S106 Inspection notice

Location:	EC3828 Circle Square Phase 1B Adj to Oxford road Manchester M1 5QA - 4200015340

Location:	Plot 14 Circle Square Upper Brook Street Manchester M1 7DN

S106 Part 1 'Application to connect to a public sewer' Approval Notice

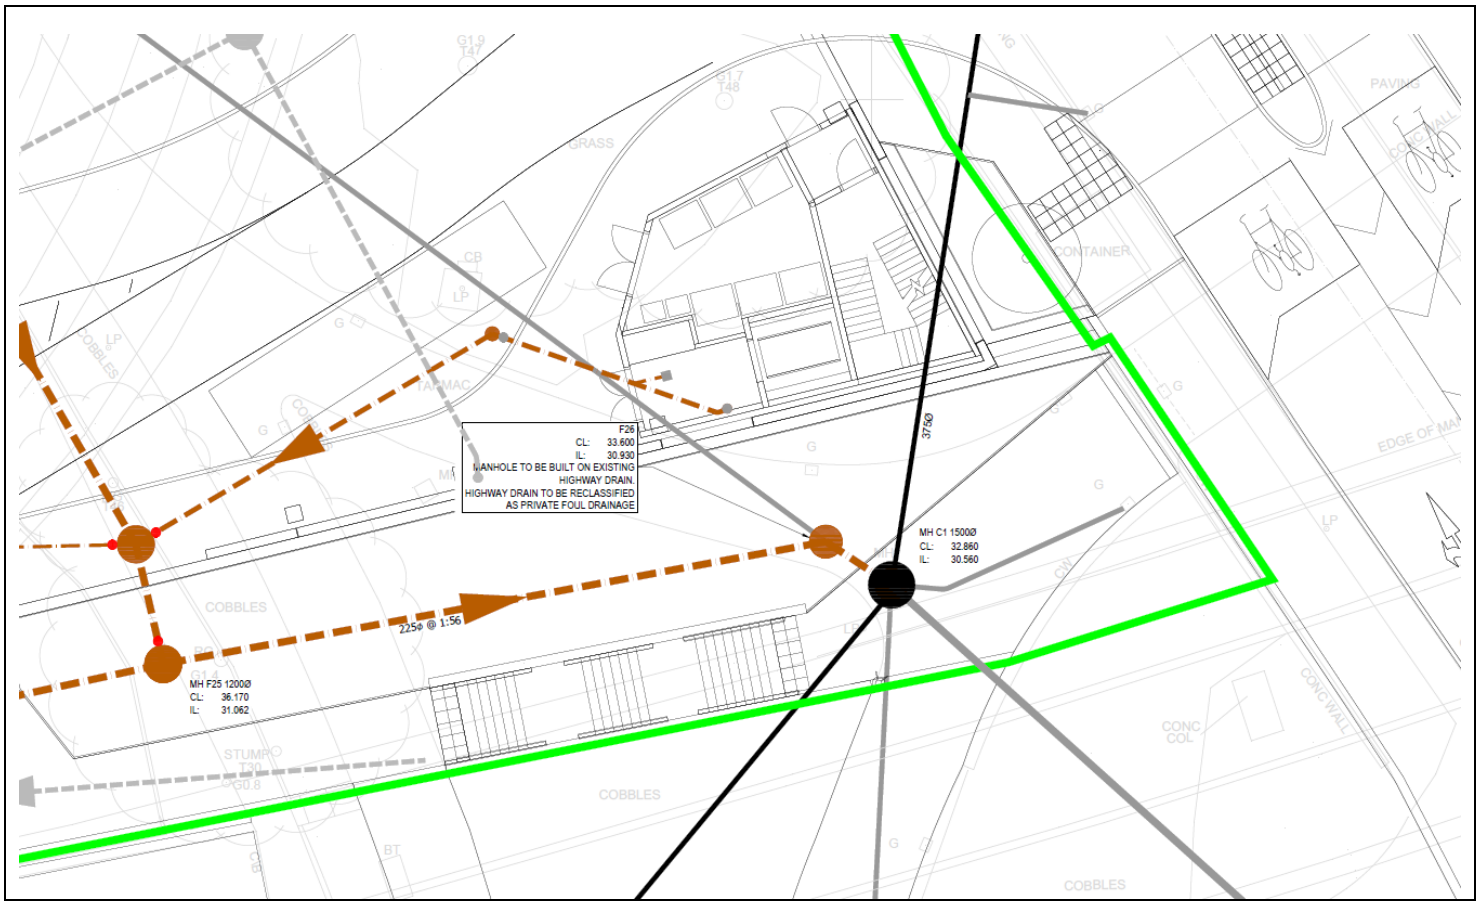
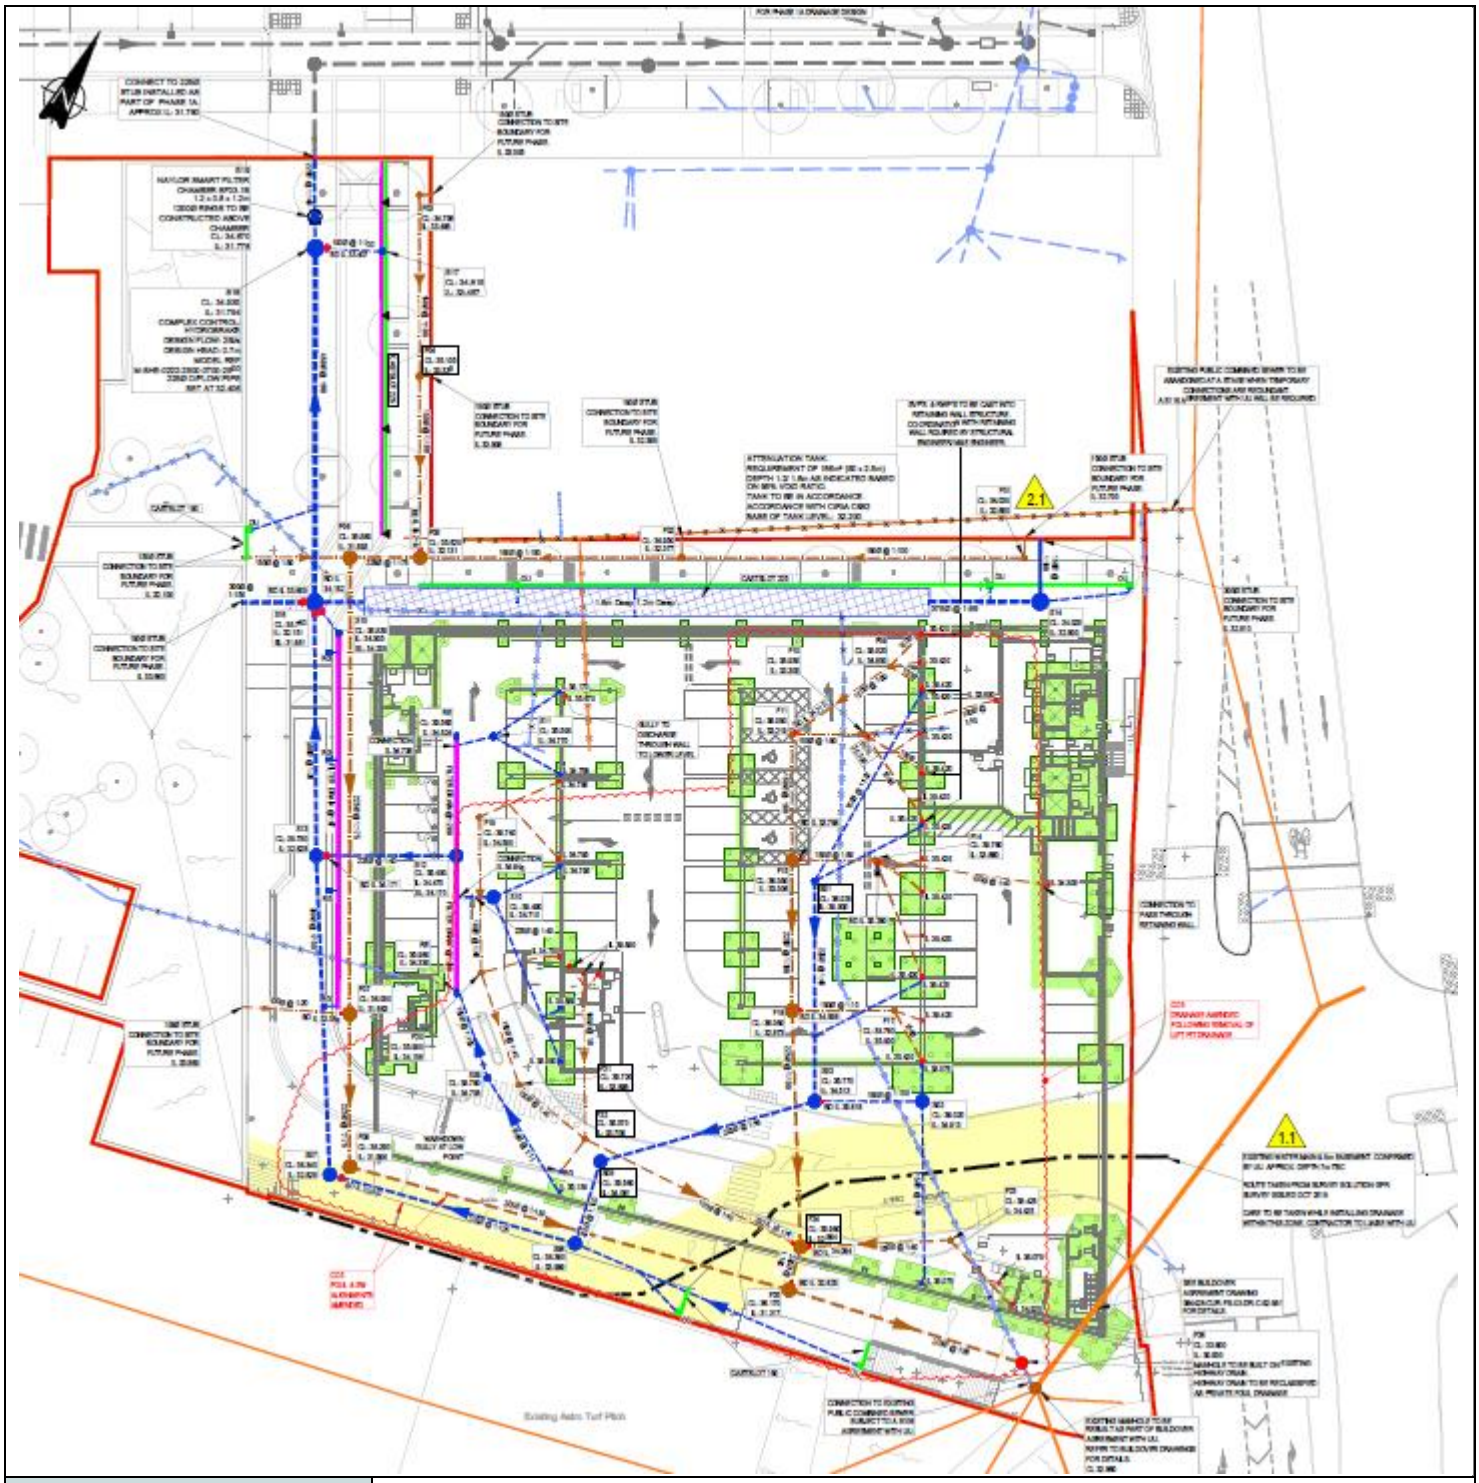
Approval granted for the 225mm Foul only connection via the utilisation of a private drain within the site boundary that shows to communicates with the 375mm Combined sewer that crosses the site through to Brook Street (as per your revised drawing below 064428-CUR-00-00-DR-C-92-530-P02)

Based on the information supplied by Andy Losty 05/10/19 that the private highway drain which is located in the land, the ownership of this has been transferred and the section of re-used drain only takes foul drainage
